# Manual 14-D Generator Operational Requirements Revision 50

Vince Stefanowicz  
Sr. Lead Engineer, Generation  
Markets and Reliability Committee  
October 31, 2019

## Changes specific to Energy Storage Resource (ESR) participation model

## Section 4.1.7: SCADA - Supervisory Control and Data Acquisition

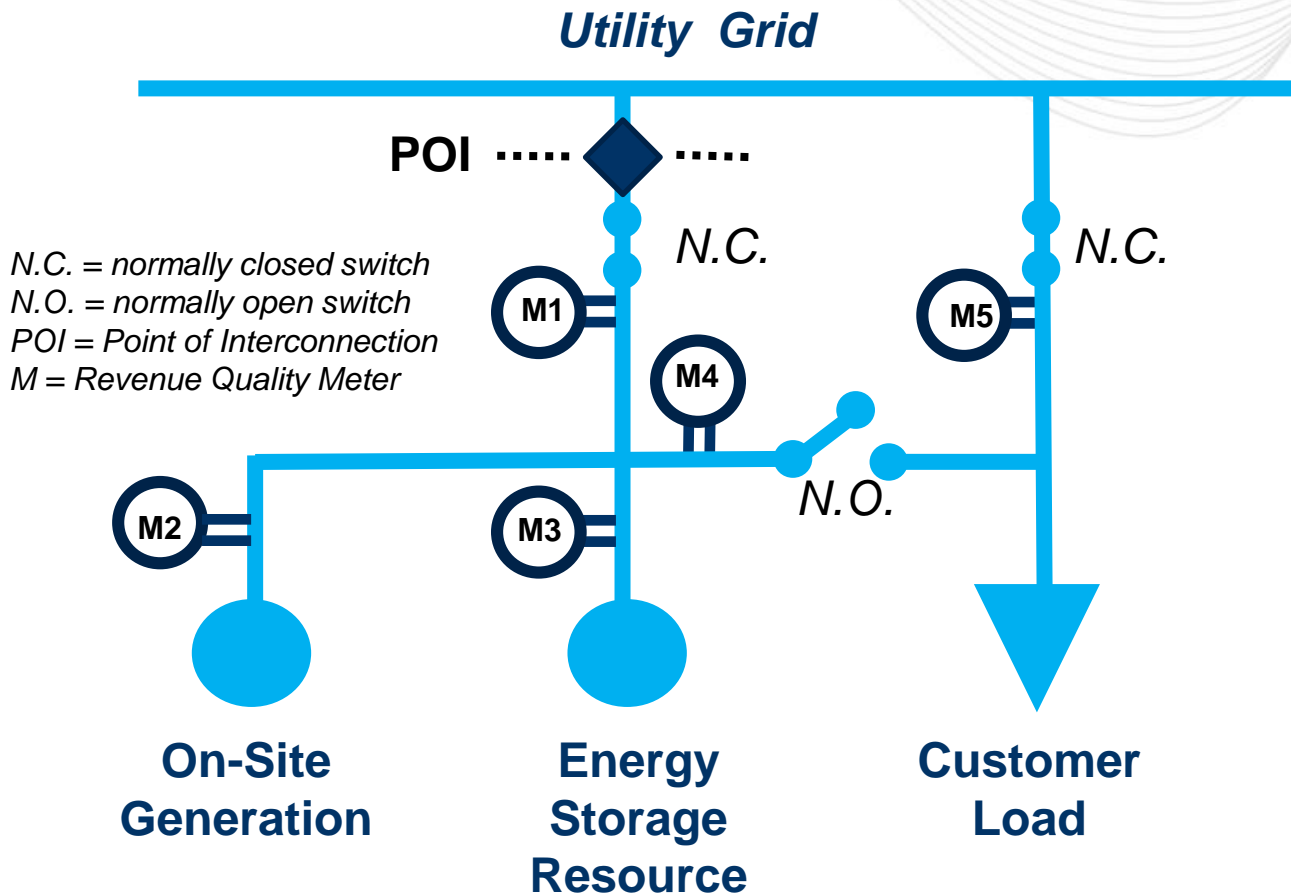
- Updated Exhibit 6 to include telemetry of State of Charge for Energy Storage Resource Model Participants

# M-14D – Changes Specific to ESR Participation Model - Metering

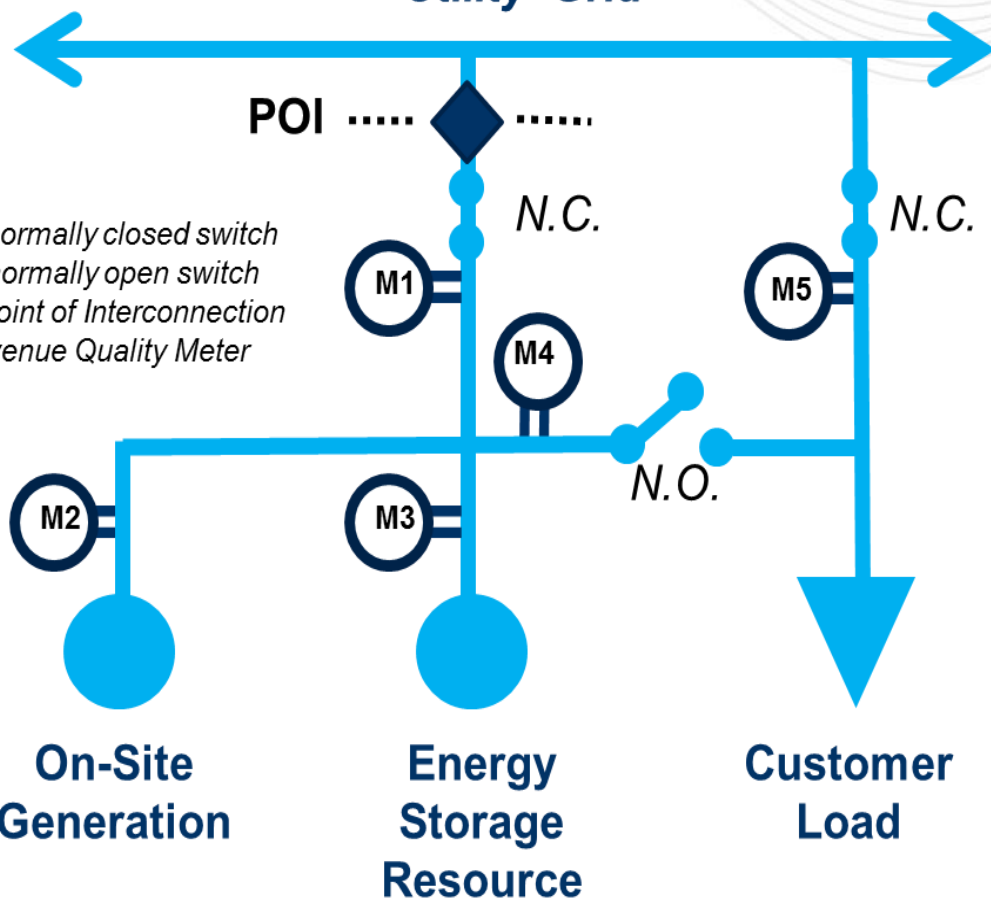
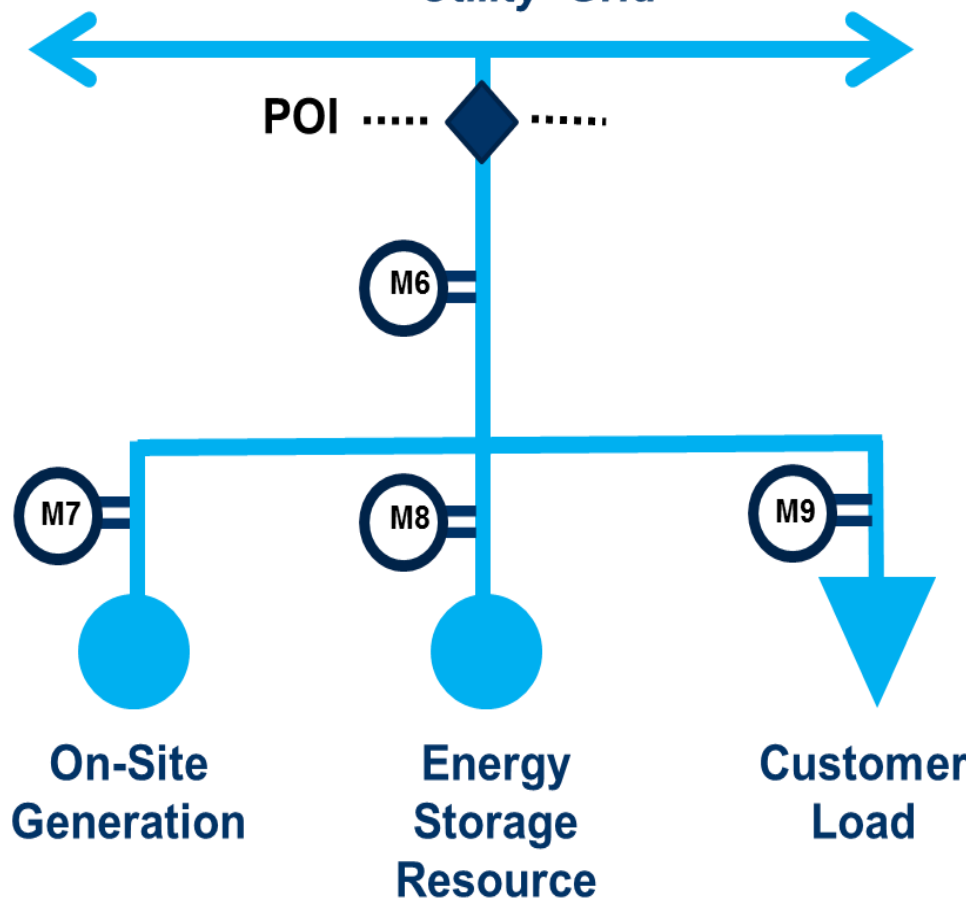
Number and location of measurement devices required will vary depending on how ESR operates

Energy Storage Resources that are co-located with end use load that is not Station Power shall provide a device for measurement of MWh located directly on the Energy Storage Resource terminals (M3 in diagram at left.)

## Attachment D: PJM Generating Unit Reactive Capability Curve Specification and Reporting Procedures

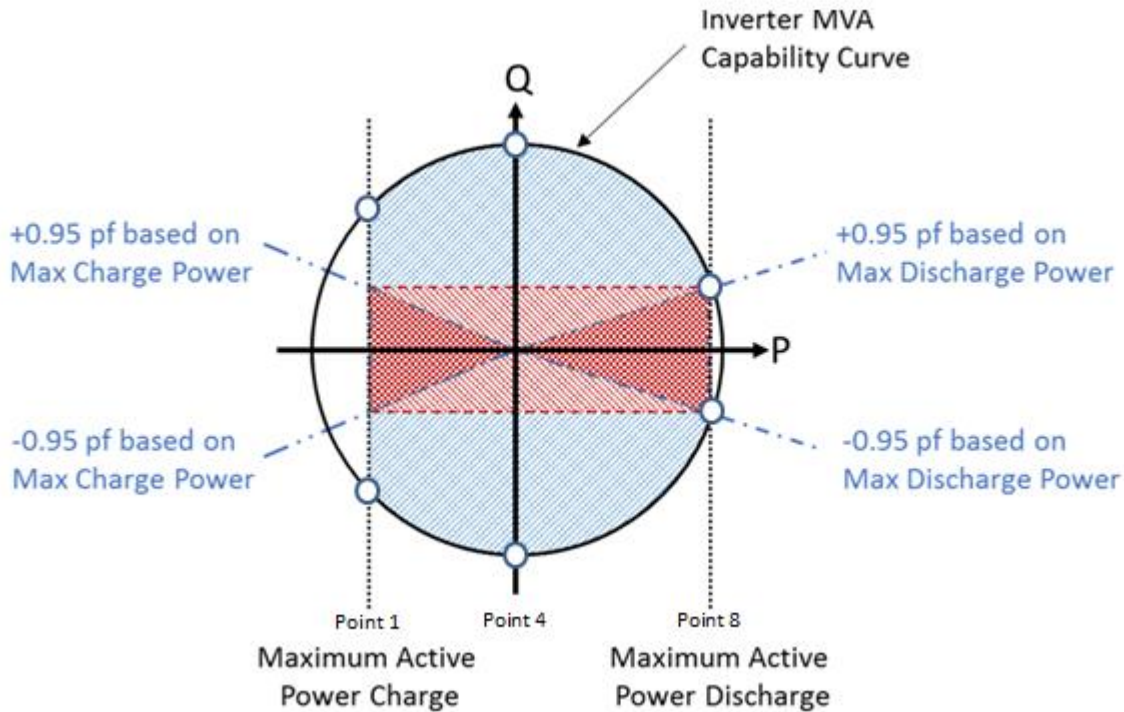
- Updated to include Energy Storage Resources
- Updated stand-alone document containing “D-curve” examples
- See example on next slide

**For inverter-based Energy Storage Resources, the reactive capability should be based on Inverter MVA Capability Curve.**
